STAFF REPORT
COMMUNITY DEVELOPMENT DEPARTMENT

HEARING DATE: 6/7/2022
 TO: Mayor & City Council
 FROM: Joseph Dodson, Associate Planner
 208-884-5533
 SUBJECT: H-2021-0103
 Ferney Subdivision

Annexation and Zoning of 5.64 acres with a request for the I-L zoning district and a Preliminary Plat consisting of two (2) building lots on 4.93 acres of land in the requested I-L zoning district.

A. Annexation & Zoning Legal Description and Exhibit Map

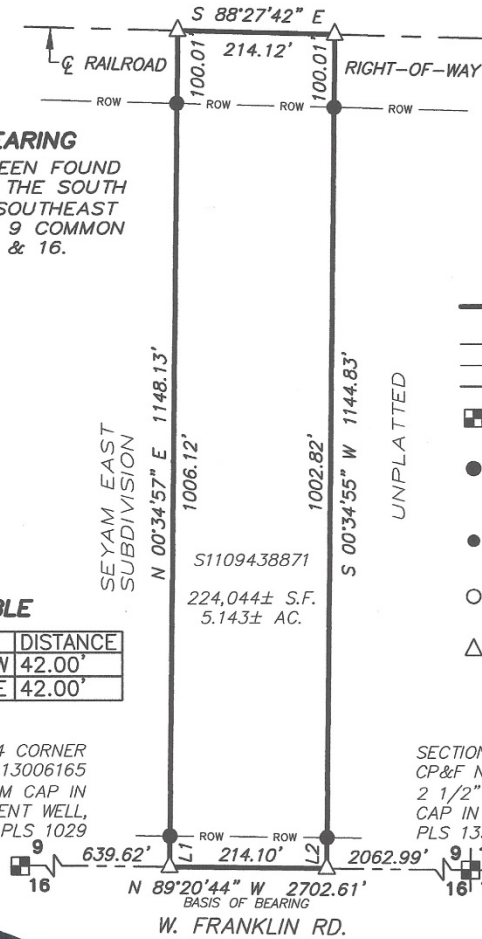
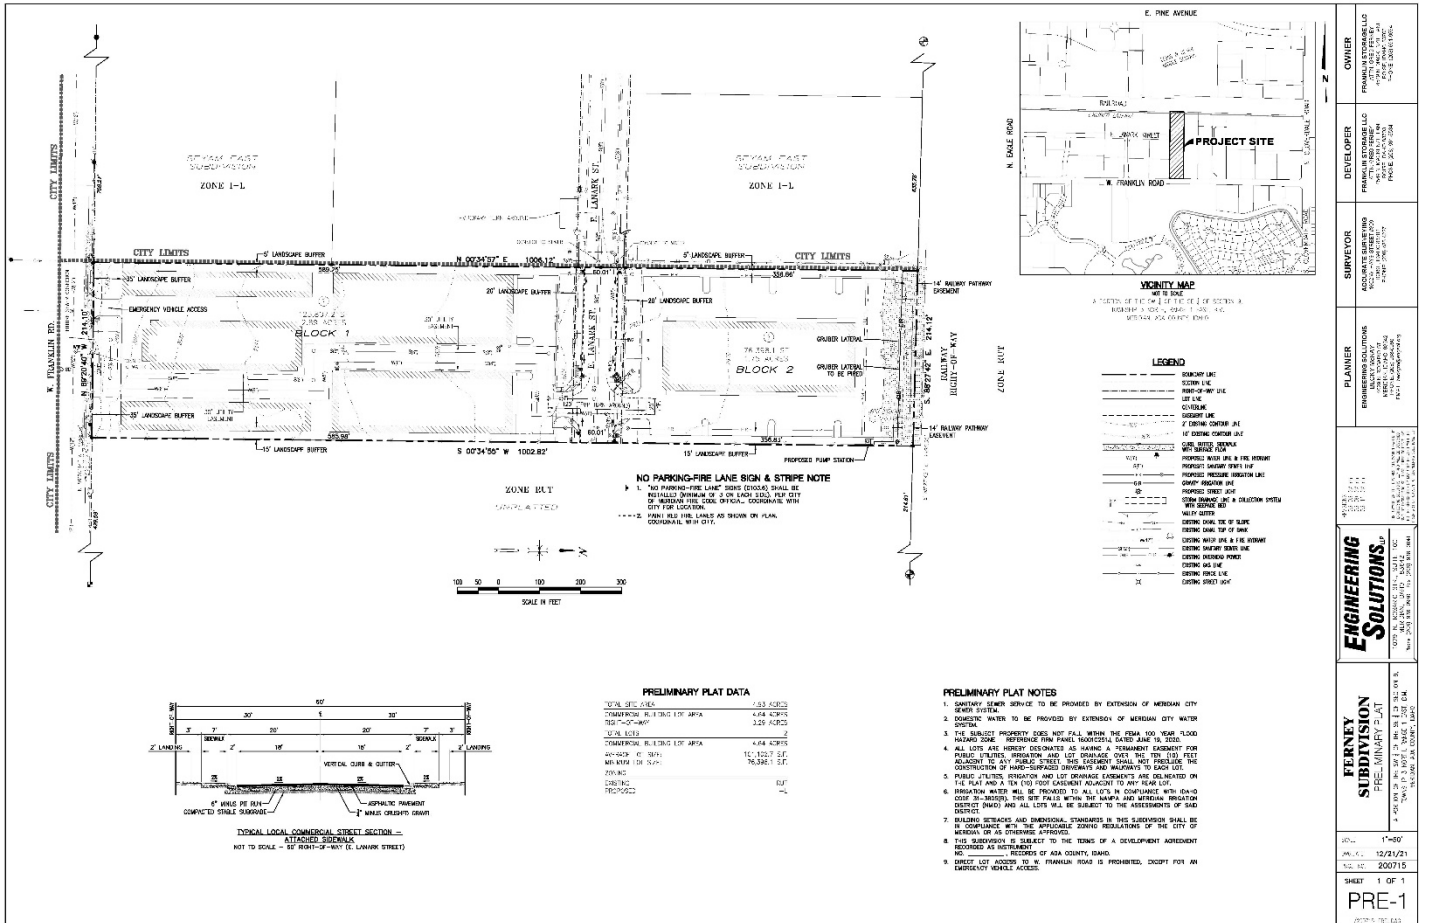
The Applicant is proposing to annex approximately 5.64 acres of land which is larger than the property size of 4.93 acres. This discrepancy is due to the Applicant being required to annex land to the centerline of adjacent right-of-way. In this case, this area includes Franklin Road right-of-way south of the property and railroad right-of-way north of the property.

With previous applications north of the subject site, Applicants did not annex to the centerline of the railroad right-of-way which was a mistake and the City did not catch it. In light of this, Staff is asking the Applicant to revise their annexation and zoning request to include the full railroad right-of-way instead of just to the centerline. Staff has included this comment within the conditions of approval.

Please submit a revised annexation legal description and exhibit map 15 days prior to the City Council hearing that includes the full width of the railroad right-of-way north of the subject site.

B. Preliminary Plat (dated: December 21, 2021)

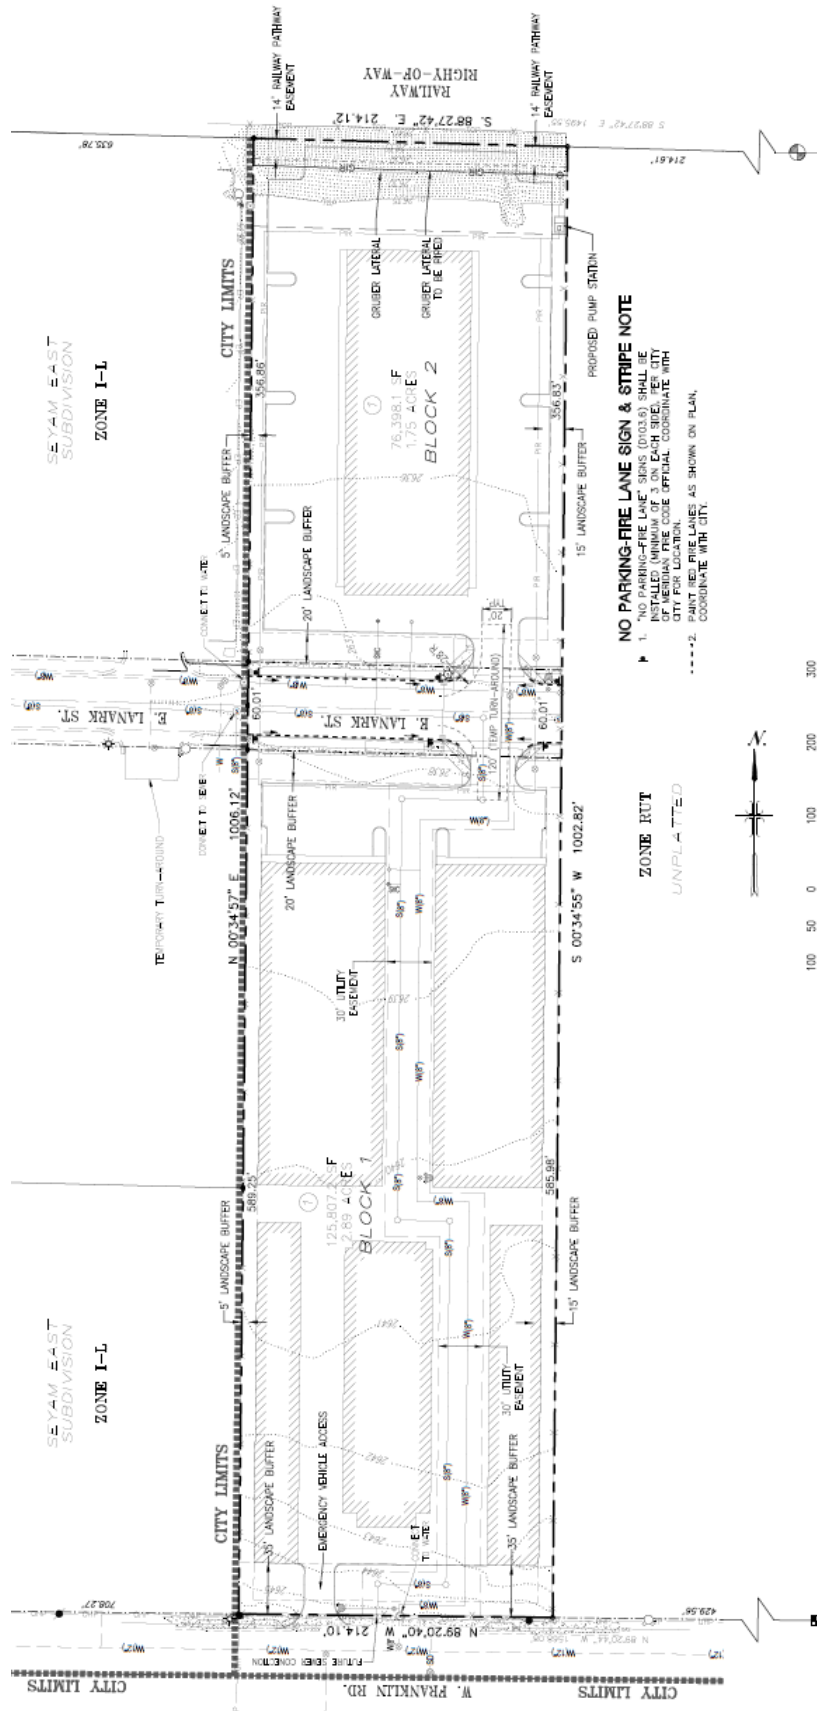
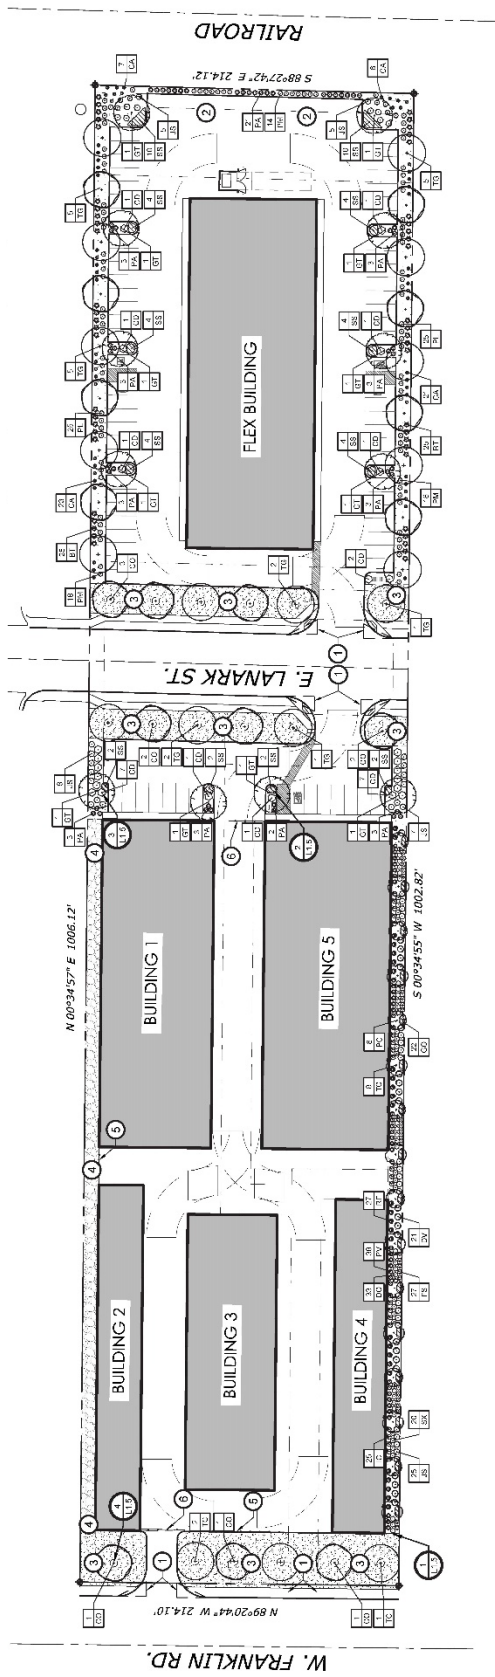
A 20-foot wide landscape buffer is required on both sides of the E. Lanark Street extension, an industrial collector street—the submitted plat depicts at least a 20 feet wide easement on both sides of this road extension measured from approximately the middle of the detached sidewalk. Therefore, the parkway strips between the sidewalks and back of curb for Lanark are not shown as part of the landscape easement.

Staff has concerns with the parkways strips not being included within the landscape buffer easements along Lanark and the lack of any vegetation shown within these parkways on the submitted landscape plans. Staff recommends the landscape buffer easement be extended to the back of curb to comply with the UDC and to revise the landscape plans to show additional grasses within the parkway strip. Further, the landscape buffers along Lanark do not show the required vegetative ground cover, similar to the Franklin buffer. Therefore, Staff is also including

2. The preliminary plat included in Section VII.B, dated December 21, 2021, shall be revised as follows at least fifteen (15) days prior to the City Council hearing:
 - a. Show the required landscape easements adjacent to E. Lanark Street to include the parkways along Lanark and start at the back of curb.
3. The landscape plan included in Section VII.D, stamped on March 16, 2022, shall be revised as follows at least fifteen (15) days prior to the City Council hearing:
 - a. Per UDC 11-3B-7C.3, depict no more than 65% of the landscape buffer area to be comprised of grasses for all required landscape street buffers (adjacent to Franklin and Lanark).

- b. Per UDC 11-3B-7C.3 for development along entryway corridors, depict additional landscape features within the 35-foot buffer along E. Franklin Road.

- c. Include additional trees and show they will touch at maturity along the east property boundary for a minimum of the first 185 feet measured from the back of the existing sidewalk for additional screening.

- d. Depict the proposed type of fencing on a sheet within the landscape plans to ensure compliance with UDC 11-3A-7 and the applicable specific use standards. Chainlink fencing with or without slats does not qualify as a screening material in accord with UDC 11-3B-5M.

LANDSCAPE PLAN

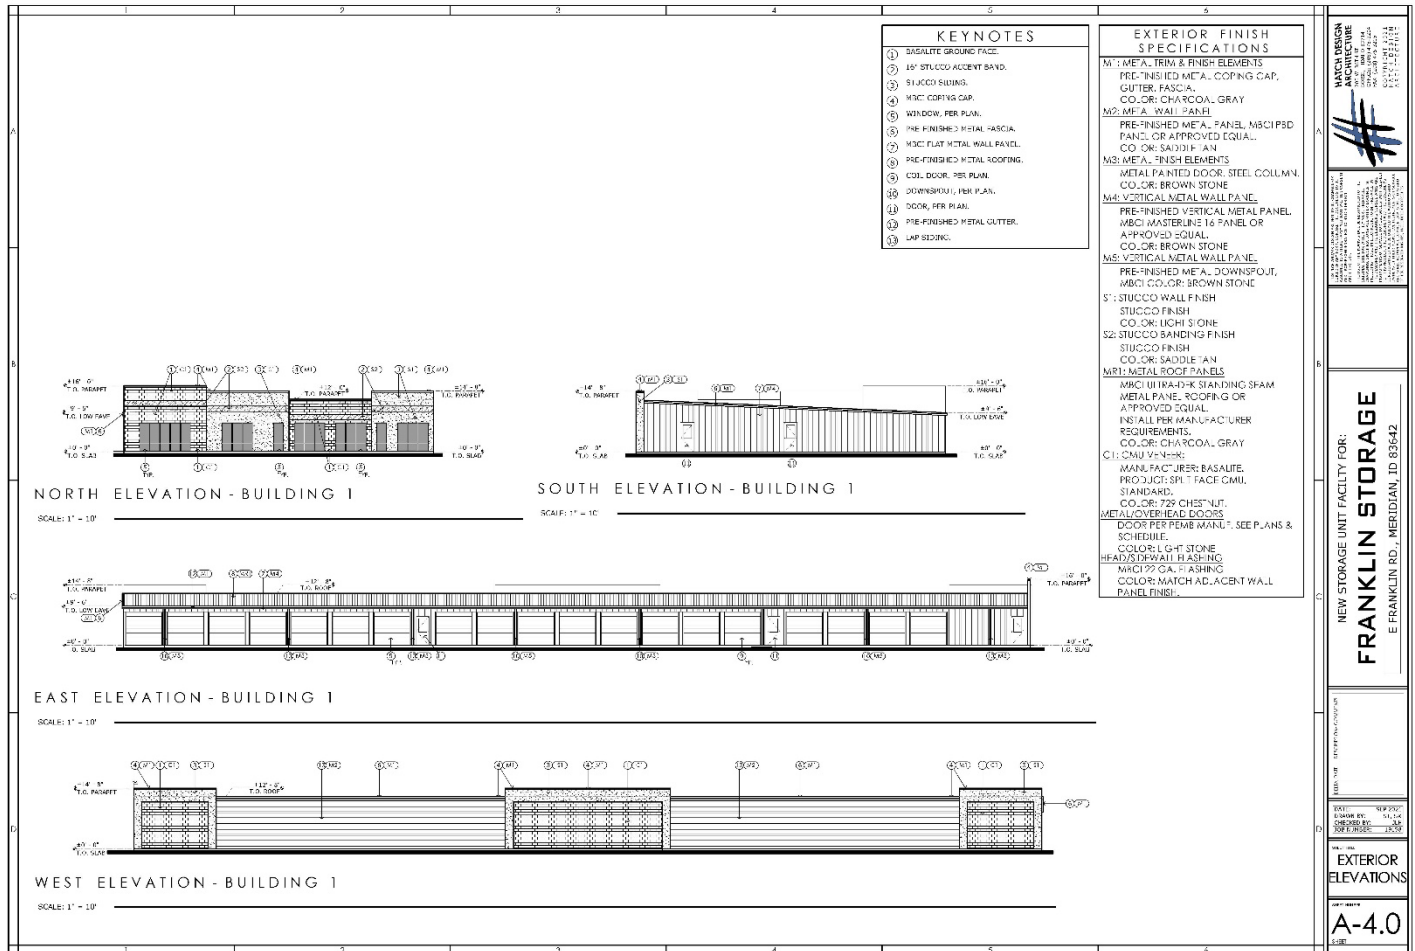
A minimum 35-foot wide street buffer is required adjacent to E. Franklin Road, an arterial street and labeled as an entryway corridor. This buffer is required to be landscaped per the standards listed in [UDC 11-3B-7C](#). According to the submitted plat and landscape plans, a minimum 35-foot landscape easement is depicted adjacent to Franklin, measured from the back of sidewalk. *The submitted landscape plans confirm the minimum width of the landscape buffer but do not appear to show code compliant vegetation. Per UDC 11-3B-7C.3, no more than 65% of the landscape buffer area shall be comprised of grasses and additional landscape design is required along entryway corridors. Therefore, additional vegetative ground cover beyond that of grasses and additional landscape features are required to meet UDC standards. For example, as outlined in code, landscape features may include berms of no less than four to one (4:1) slope at a three-foot minimum height, decorative landscape walls (no greater than three (3) feet in height), decorative open vision fencing (no greater than four (4) feet in height), or a dry creek design with river rock, boulders, etc. are acceptable to meet this standard. Staff has included a condition of approval to comply with this standard. However, there are existing power poles along the Franklin frontage so the Applicant will be limited to Class I trees only; this does not preclude the Applicant from meeting the maximum ground cover percentage noted above.*

No fencing is shown on the submitted landscape plan but fencing is required per the specific use standards for the proposed self-service storage facility use adjacent to the existing residential use to the east. Staff is including a condition of approval to include code compliant fencing along the entire east property boundary.

Because this area of the plat is adjacent to a vehicular use area around the Flex building, parking lot landscaping is required per UDC 11-3B-8 and should include trees and other vegetative ground cover. The submitted landscape plans do not depict any trees within this area as the irrigation easement does not allow trees. Further, the Applicant will need to obtain a license agreement with the irrigation district in order to construct what is shown on the landscape plans. Staff does not find what is proposed on the landscape plans to comply with the minimum code requirements discussed. The Applicant should submit for Alternative Compliance with the future final plat to propose an equal or superior means of complying the landscaping outlined in UDC 11-3B-8 within or adjacent to the Evans Drain easement.

a condition of approval to add additional vegetative ground cover beyond grass to comply with UDC 11-3B-7C.3.
